PUR-1401
ADDENDUM NO. 5
INVITATION TO BID

WASHINGTON COUNTY PUBLIC SAFETY TRAINING CENTER

DATE: Thursday, September 10, 2020

1	AREA A - PARTIAL ROOF FRAMING PLAN
S1.13	SCALE: 1/8" = 1'-0"

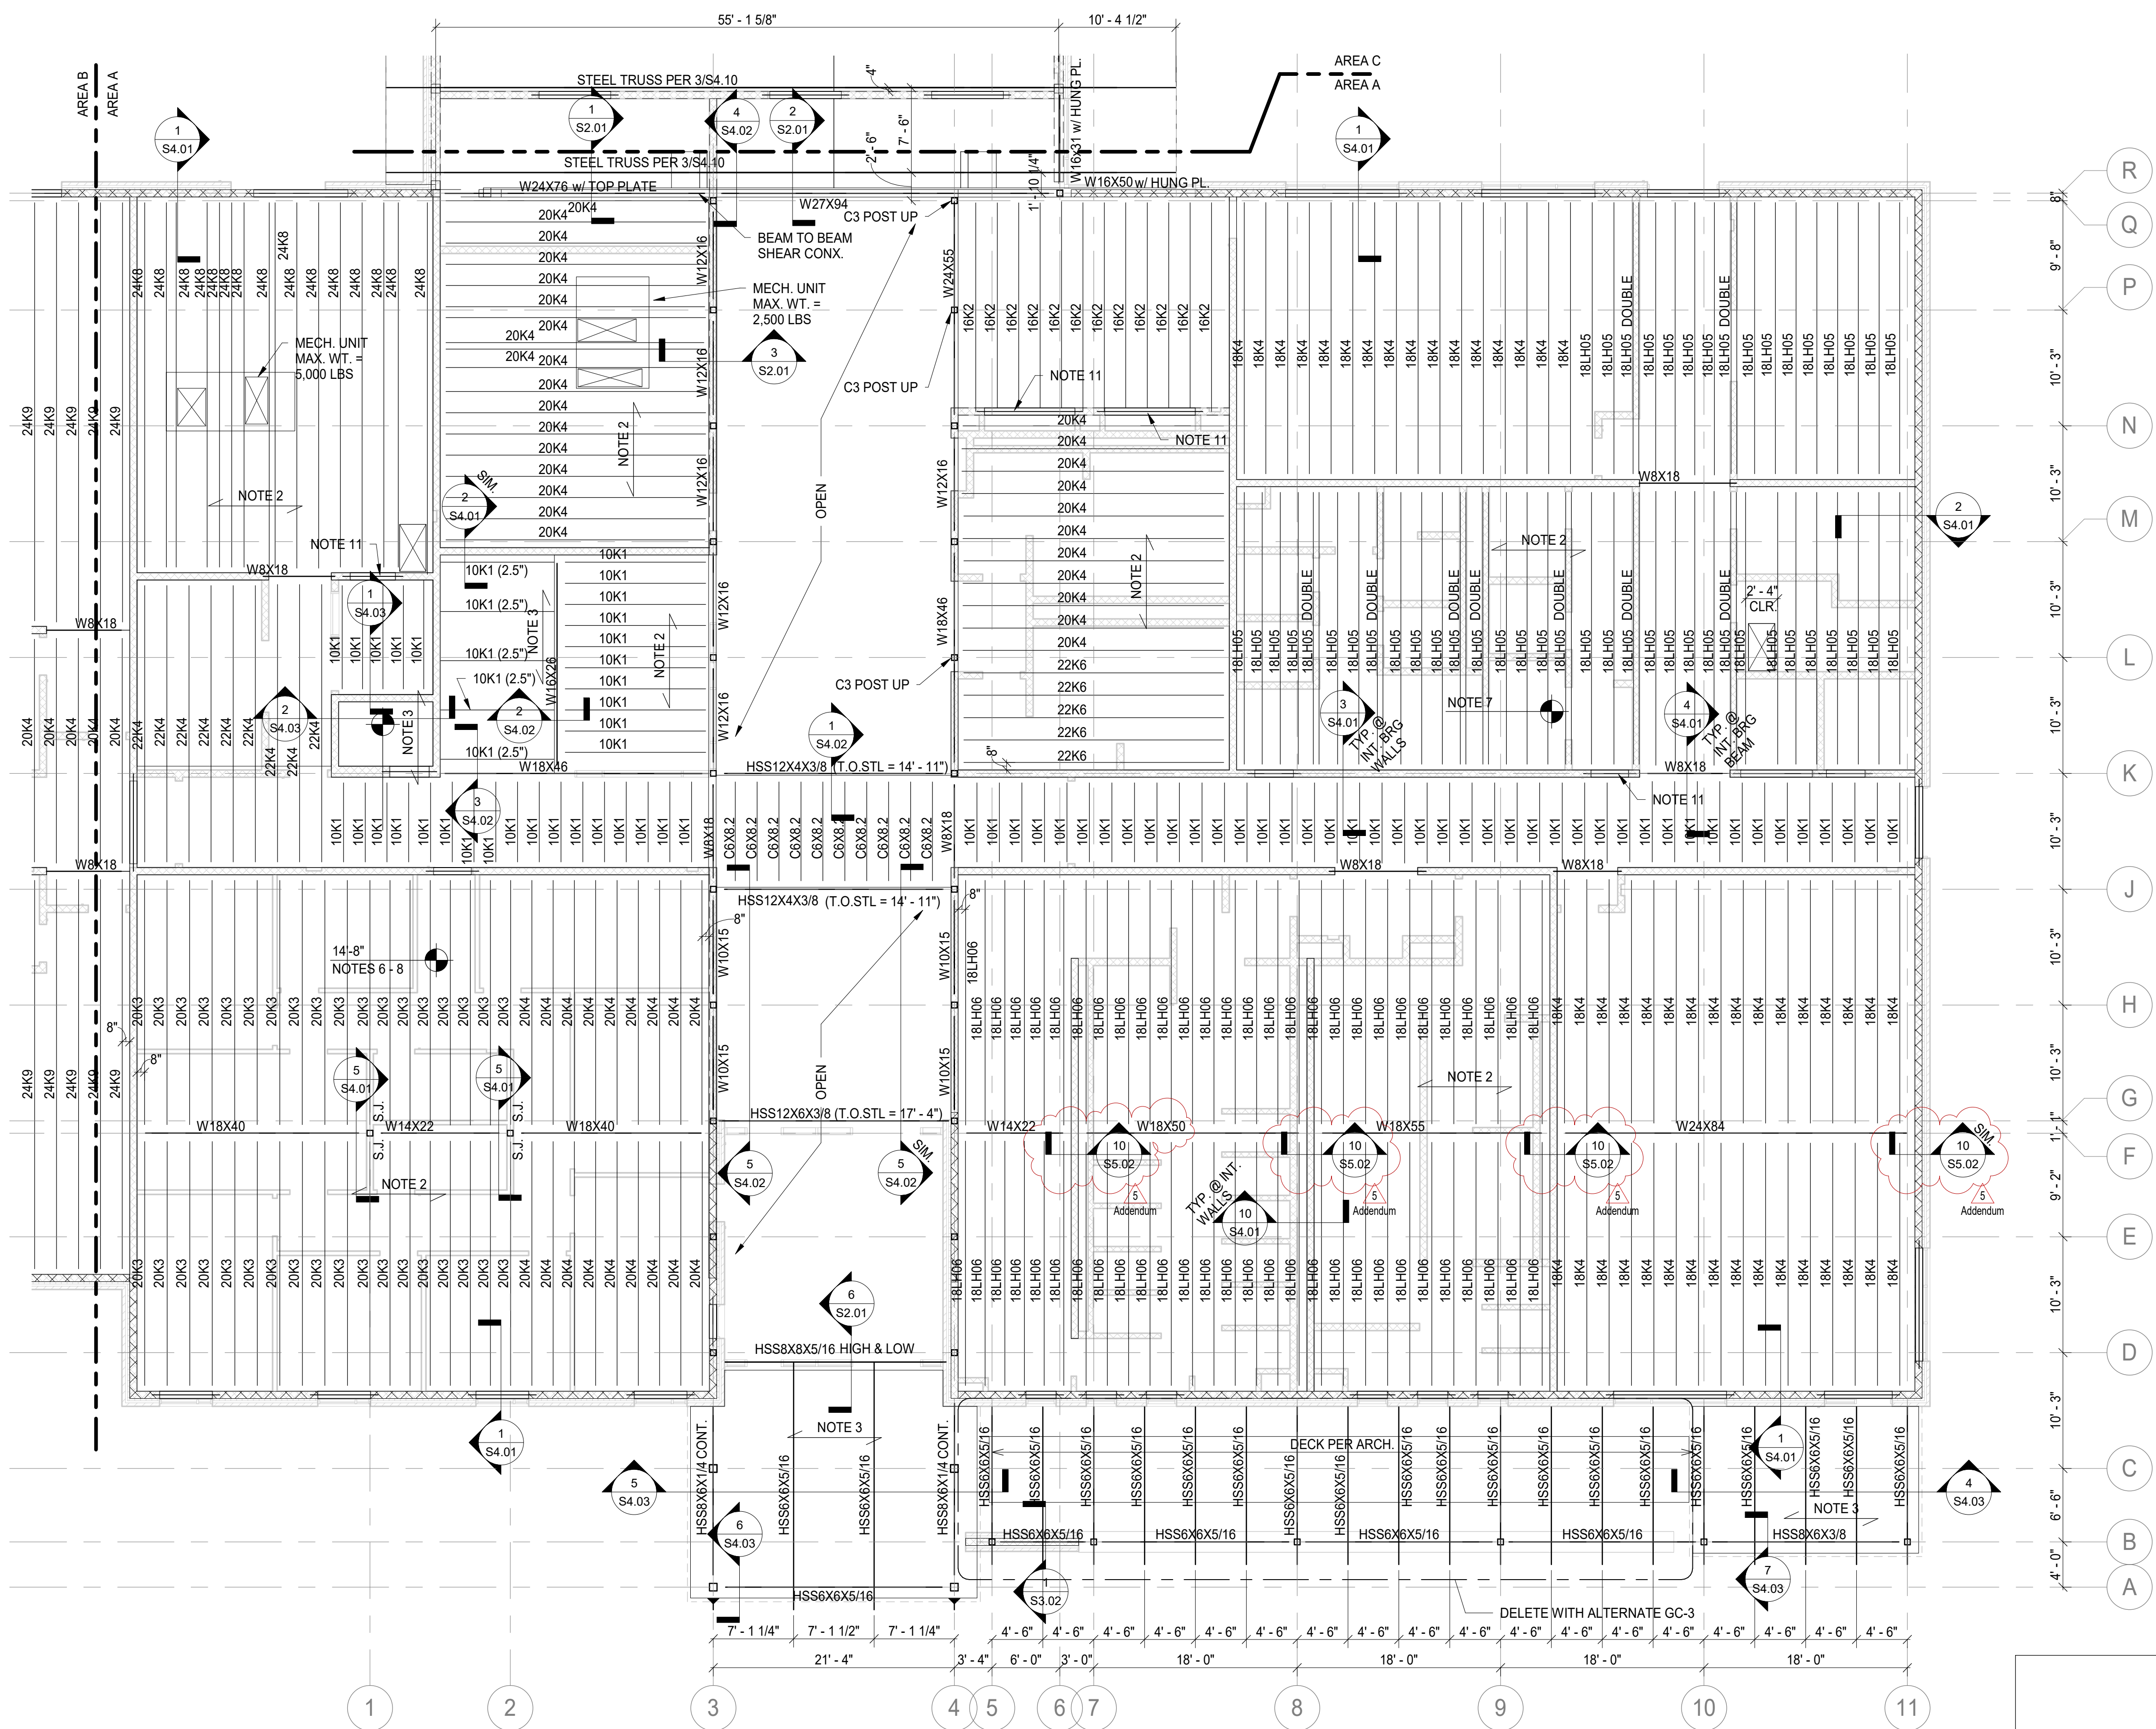
- ITEM NO. 47:** Drawing S1.13, Fut. 2nd Floor/ Roof Framing Plan – Area A, ADD and REVISE the following:
1. **ADD** section cuts along column grid “G”. See attached revised drawing.
 2. **CHANGE** beam size along Grid “G” Between Grids 7 and 8. See attached revised drawing, (Attachment H).
- ITEM NO. 48:** Drawing S1.14, Fut. 2nd Floor/ Roof Framing Plan – Area B, FLOOR FRAMING PLAN NOTES, Note #6; **ADD** note to read, “**PROVIDE CEILING EXTENSIONS IN ALL AREAS.**” See attached revised drawing, (Attachment I).
- ITEM NO. 49:** Drawing S5.02, Typical Masonry Wall Details; **CHANGE** and **ADD** the following:
1. Detail 5/S5.02, REVISE note per attached revised drawings.
 2. ADD Detail 10/S5.02 – Beam Bearing on CMU Wall, per attached revised drawing, (Attachment J).
